TECHNICAL EVALUATION REPORT ON THE ADEQUACY OF
ELECTRIC DISTRIBUTION SYSTEM VOLTAGES
FOR THE POINT BEACH NUCLEAR PLANT
UNITS 1 AND 2

(Docket Nos. 50-266, 50-301)

February 9, 1983

FIGURE 1 POINT BEACH NUCLEAR PLANTS UNITS 1 & 2 - ELECTRICAL ONE-LINE DIAGRAM

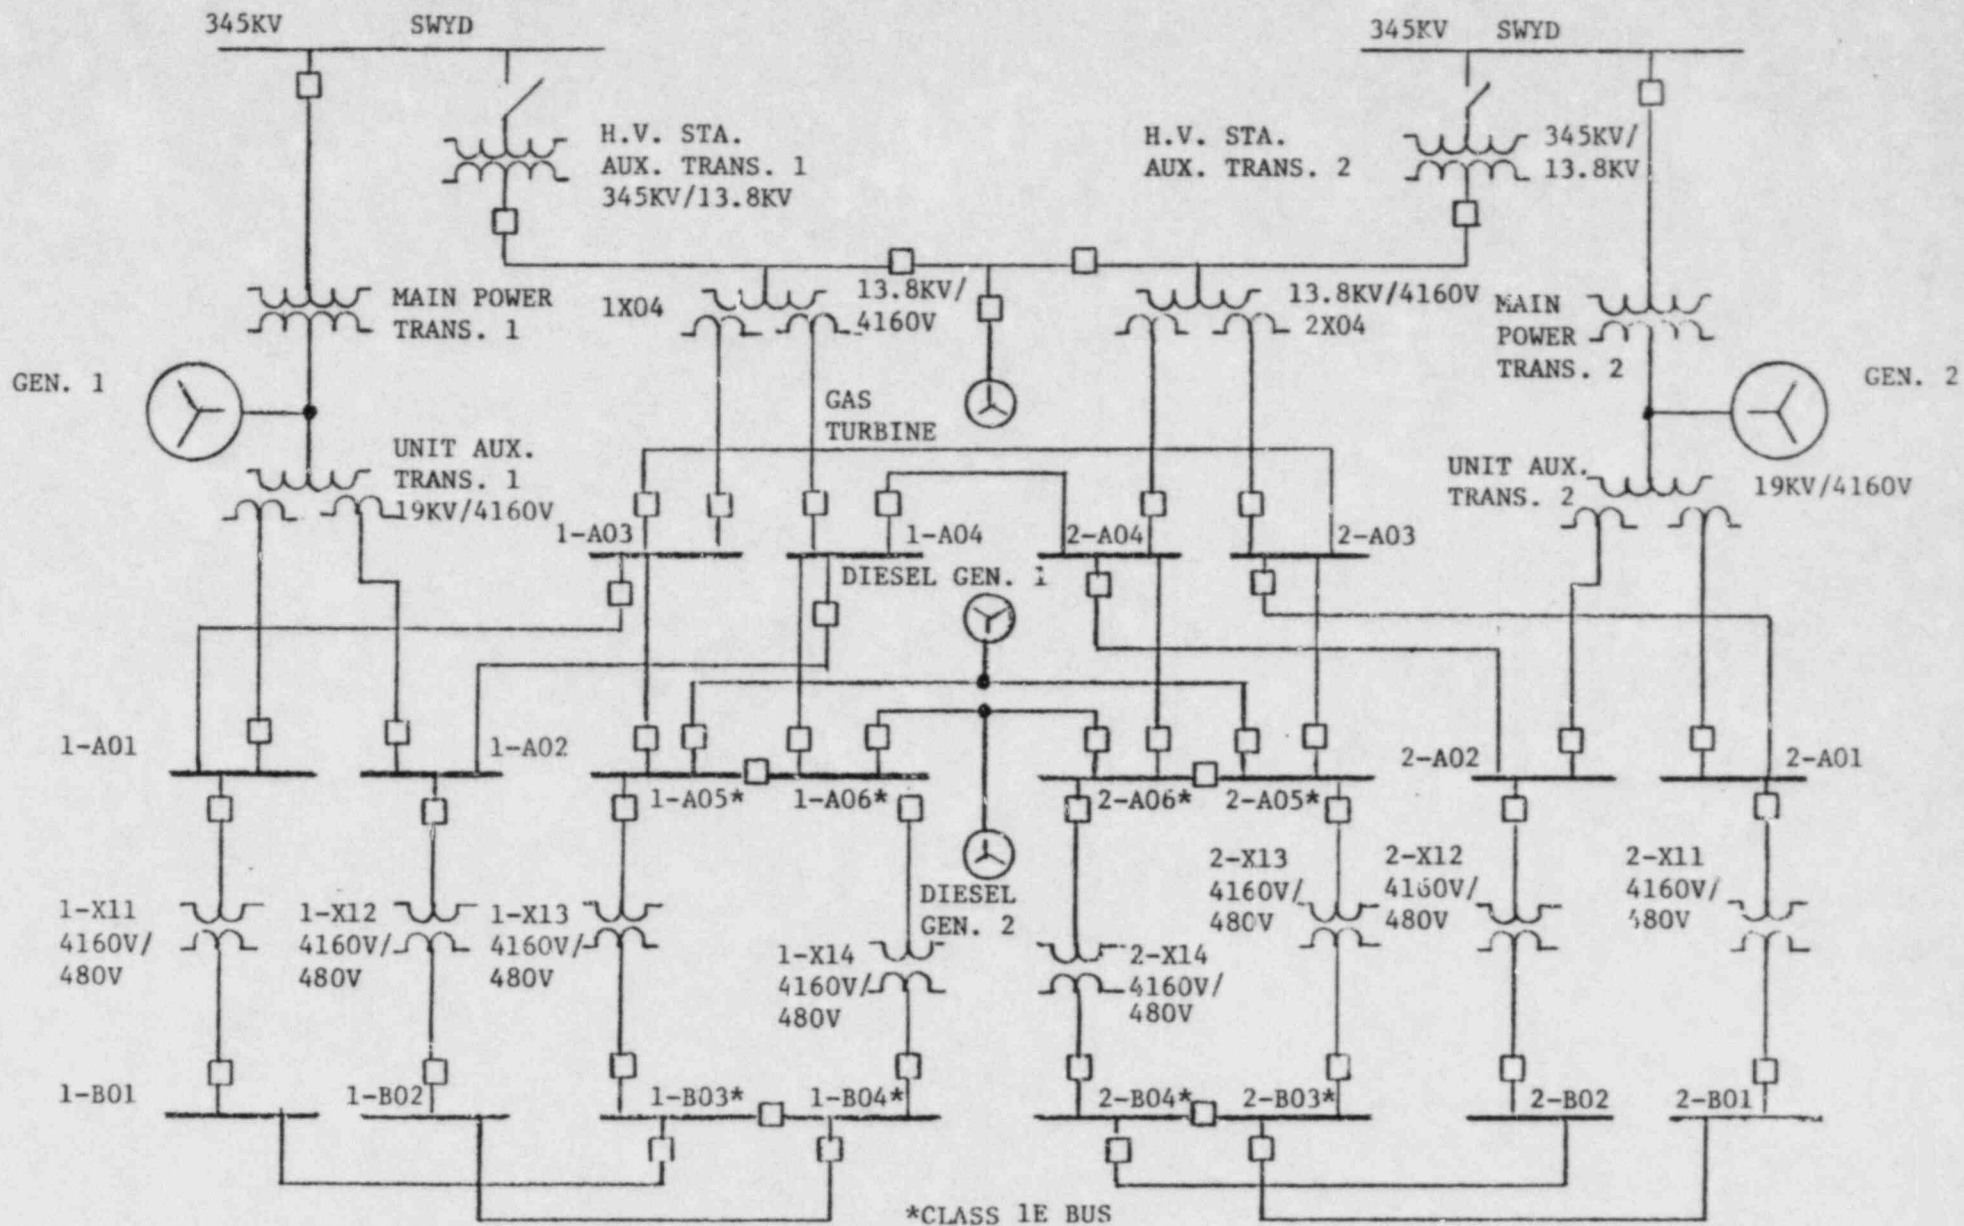
A one-line diagram of Point Beach Nuclear Plant's (PBNP) electrical distribution system is shown in Figure 1. This figure was adapted from Attachment 1 of Wisconsin Electric Power Company's (WEPCO) letter of January 21, 1981 [Ref. 3]. A 345 kV switchyard energizes two 345/13.8 kV high voltage auxiliary transformers. The high voltage auxiliary transformers energize two low voltage 13.8/4.160 kV transformers which in turn energize the 4160-volt Class 1E buses.

There are two 4160-volt Class 1E buses and two 480-volt Class 1E buses for each unit. The 4160-volt Class 1E buses A05 and A06 are energized by switching-buses A03 and A04 for each unit. A03 and A04 also energize non-Class 1E buses A01 and A02 during shutdown and startup. The Class 1E buses are not energized by the unit auxiliary transformer, but are energized from the

offsite source through the low voltage station auxiliary transformers. If the voltage on the 345 kV switchyard buses falls below 350 kV an alarm is initiated in the plant control room and at the system control center to alert the operators to attempt voltage adjustments. In the event of loss of offsite power or a degraded offsite voltage condition, the Class 1E buses are automatically transferred to the emergency diesel generators [Ref. 10]. In the event of a unit trip or plant shutdown, the non-Class 1E buses A01 and A02 are transferred to A03 and A04.

The licensee was requested to evaluate the proximity of the 1X04 and 2X04 transformers for the possibility of a fire or similar accident in one transformer having a detrimental effect on the other transformer. This issue is being investigated by the NRC Region 3 office.
